FOR YOUR REVIEW AND COMMENT

ELEMENTARY WIRING DIAGRAM
PUMP MOTOR CONTROLS

B-SYS-80-414-301 01

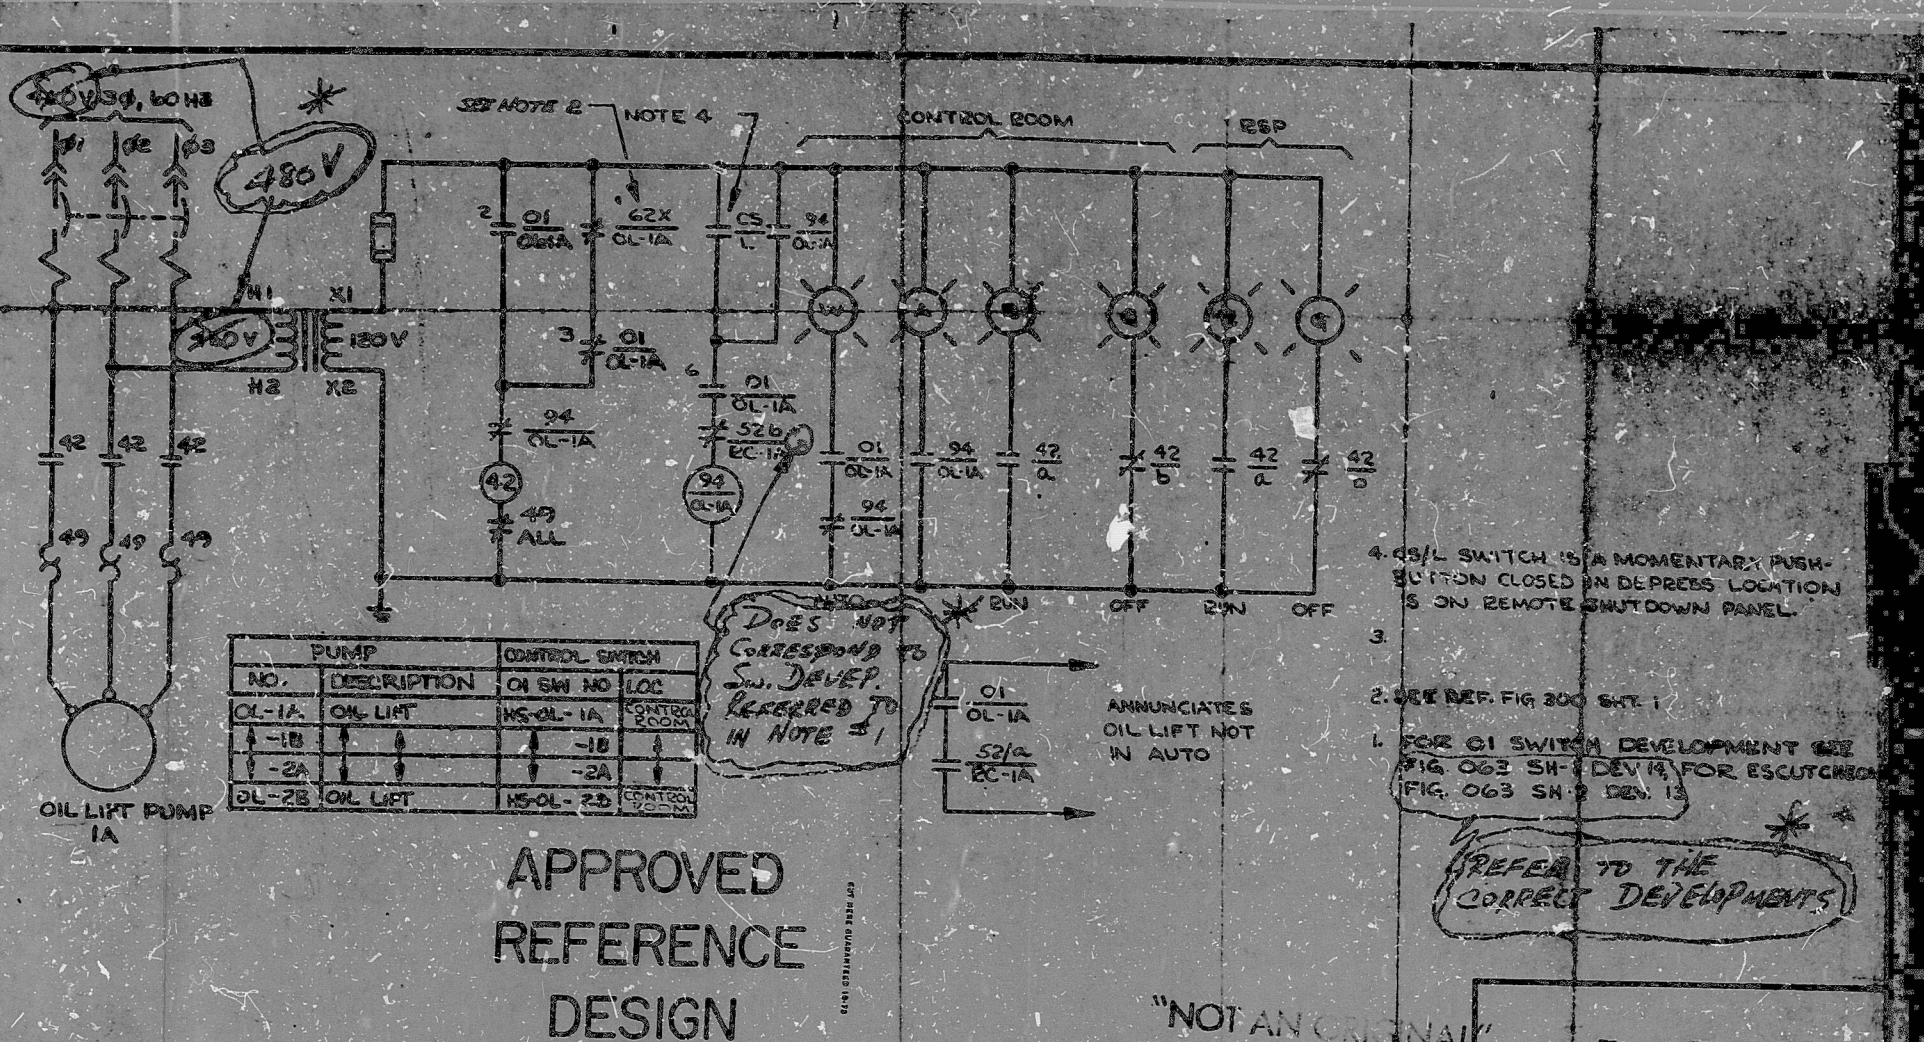
REFER TO THE
CORRECT DEVELOPMENTS
